WATER RESOURCES DEPARTMENT

PUBLIC INTEREST REVIEW FOR GROUND WATER APPLICATIONS

SUBJECT: Application G- **17210** Supersedes review of _____
Date of Review(s)

A. GENERAL INFORMATION: Applicant's Name: **Collin & Debbie Crocker** County: **Benton**

Ground Water Application G-17210, Crocker
Benton County, Harrisburg & Monroe Quads

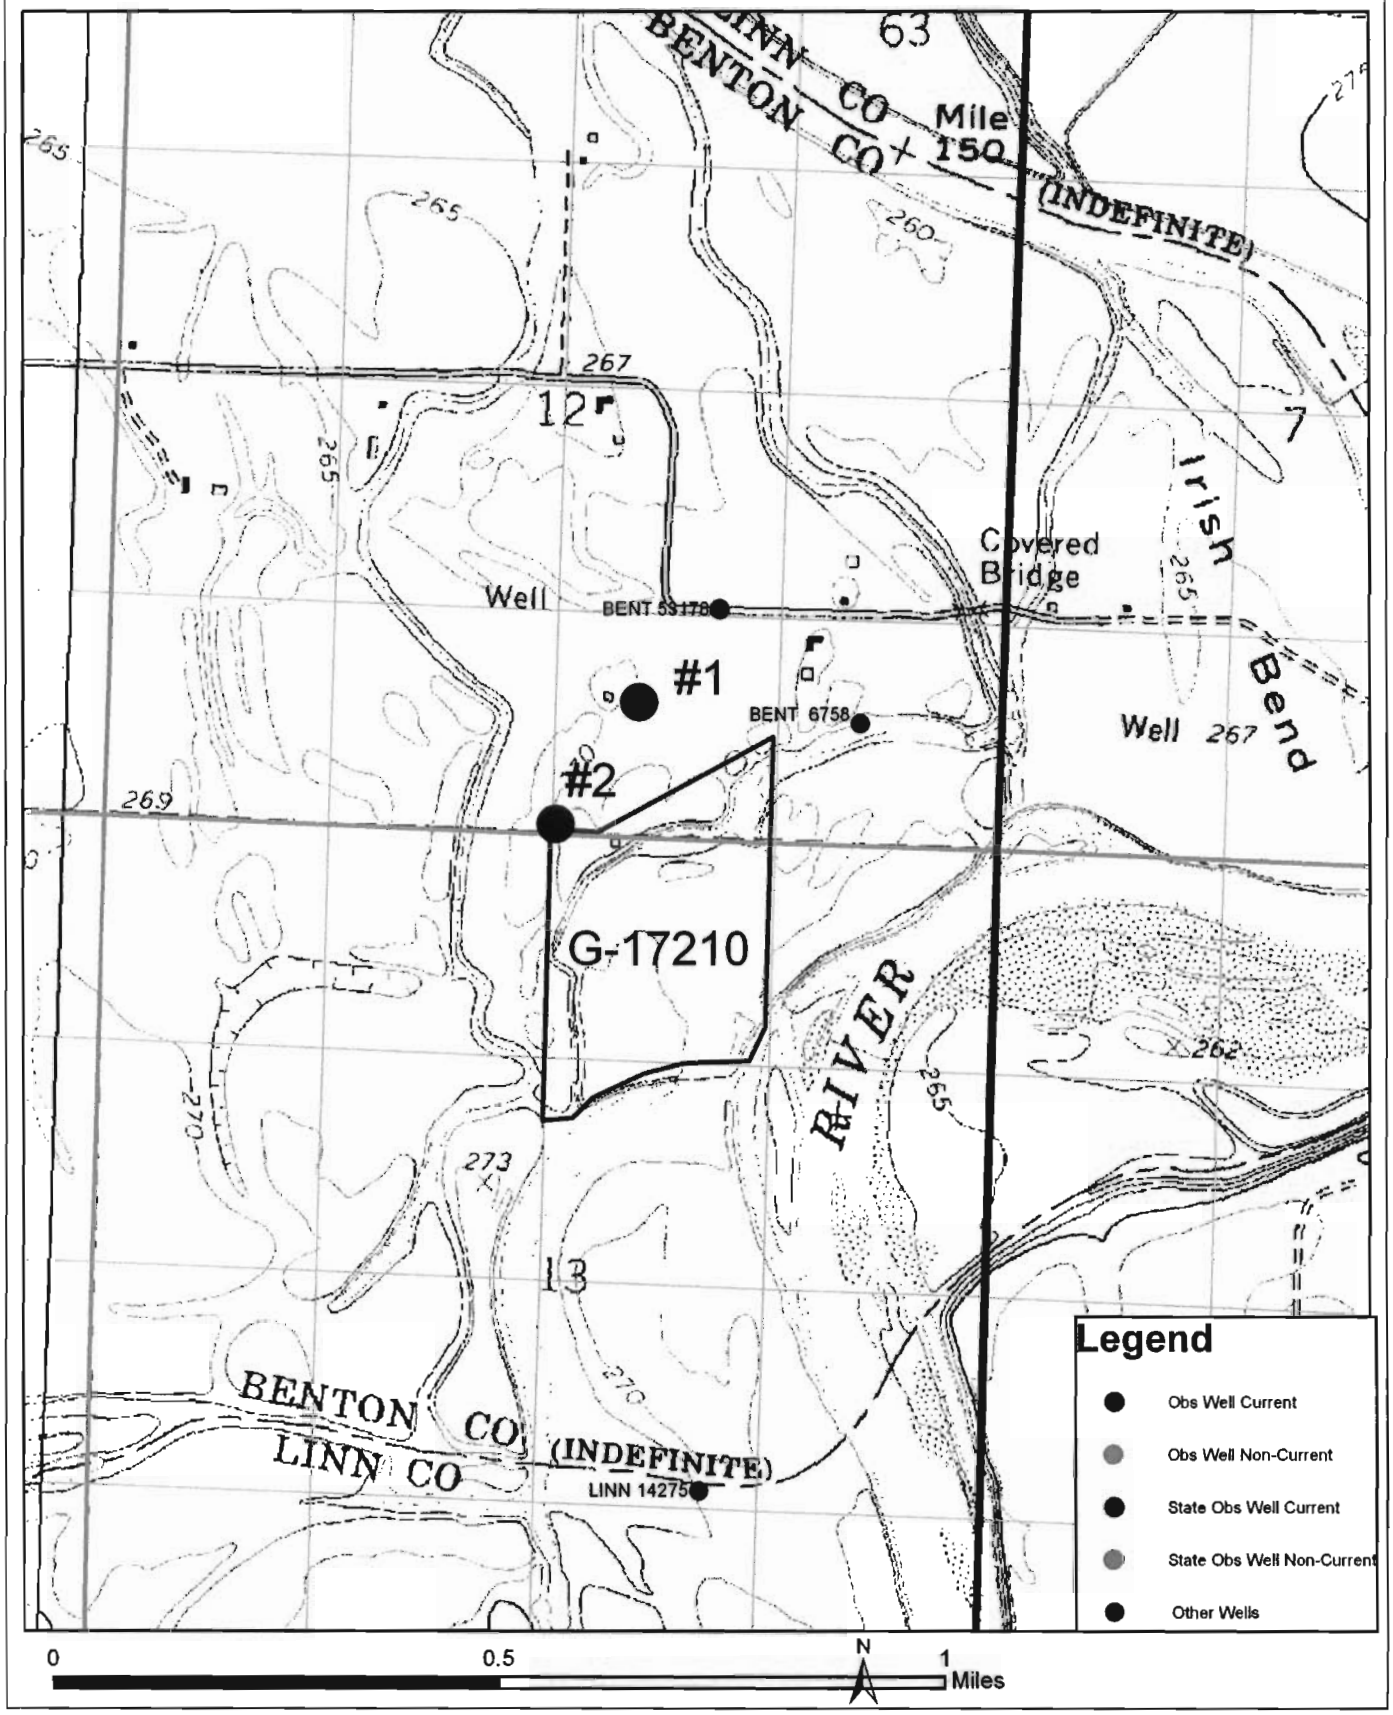
B3. **Ground water availability remarks: The wells will develop water from an aquifer that is hydraulically connected to the Willamette River.**

Basis for aquifer hydraulic connection evaluation: **Shallow wells developing water from sand and gravels in the flood plain of the Willamette River.**

d. ☒ **will, if properly conditioned**, avoid injury to existing ground water rights or to the ground water resource:
   i. ☒ The permit should contain condition #(s) **7F - Well Location + Large monitoring and reporting with flow meters at both wells**;
   ii. ☐ The permit should be conditioned as indicated in item 2 below.
   iii. ☐ The permit should contain special condition(s) as indicated in item 3 below;
